CALLEGUAS MUNICIPAL WATER DISTRICT
Thousand Oaks, California

PROJECT NO. 450

FOR THE CONSTRUCTION OF THE
LVMWD-CMWD INTERCONNECTION

ADDENDUM NO. 2

NOTE:
IN ADDITION TO POTHOLING REQUIRED BY GC 5.24.7. POTHOLE TO LOCATE NEAREST EXISTING JOINTS ALONG EXISTING LINDERO FEEDER NO. 2 PIPELINE ON BOTH SIDES OF AND ALONG THE NEW PIPE CONNECTION SHOWN IN DETAIL 3. INCLUDE SURVEYED POTHOLE DATA IN POTHOLING REPORT PER GC 5.24.10.

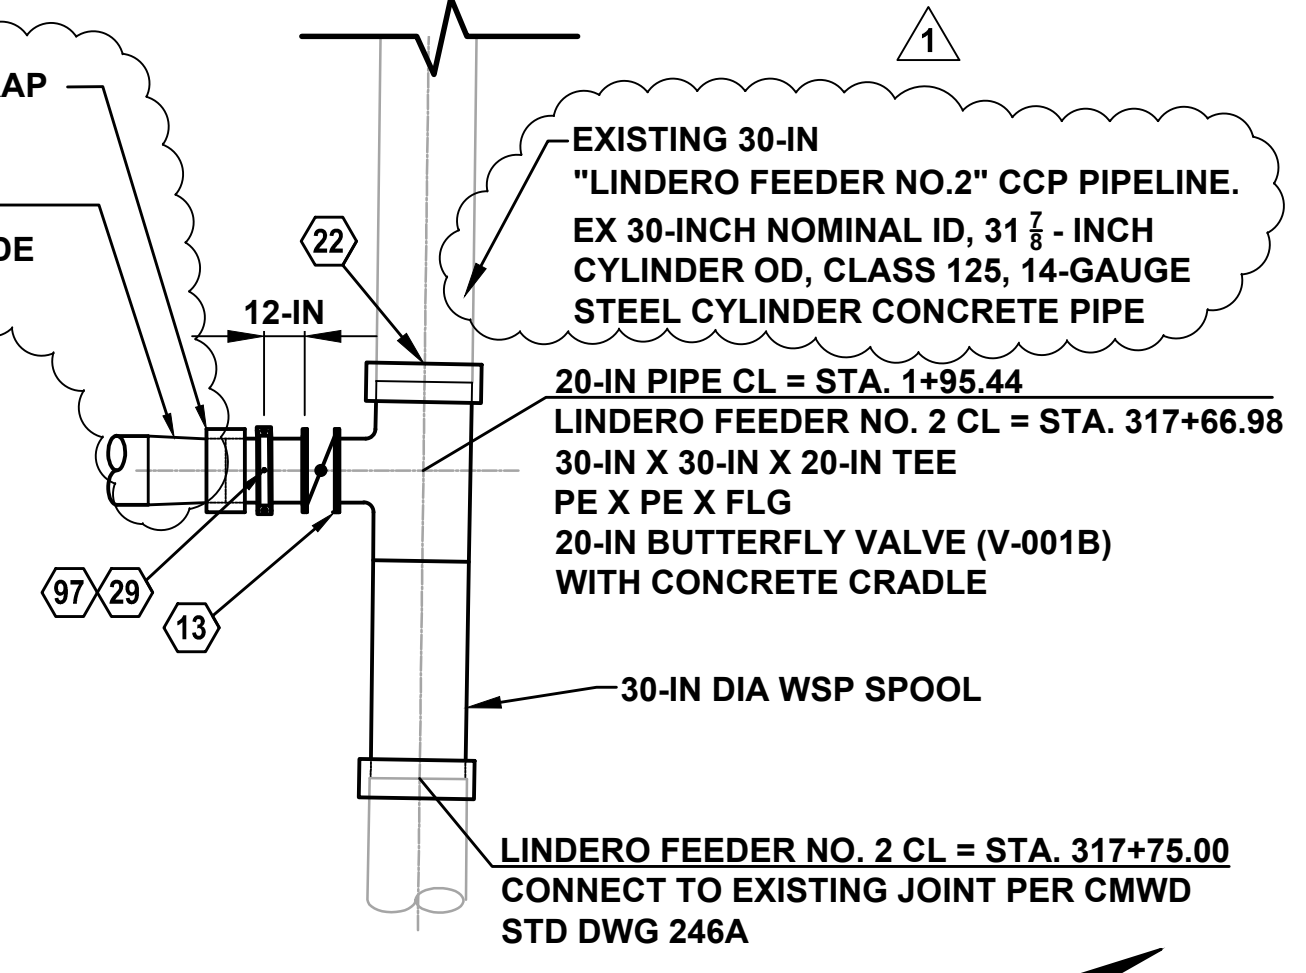
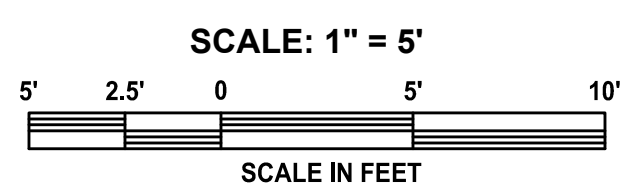
- Item AD2-54 REPLACE Drawing C-32 with the attached Exhibit H4, containing replacement Drawing C-32.
- Item AD2-55 REPLACE Drawing C-38 with the attached Exhibit H5, containing replacement Drawing C-38.
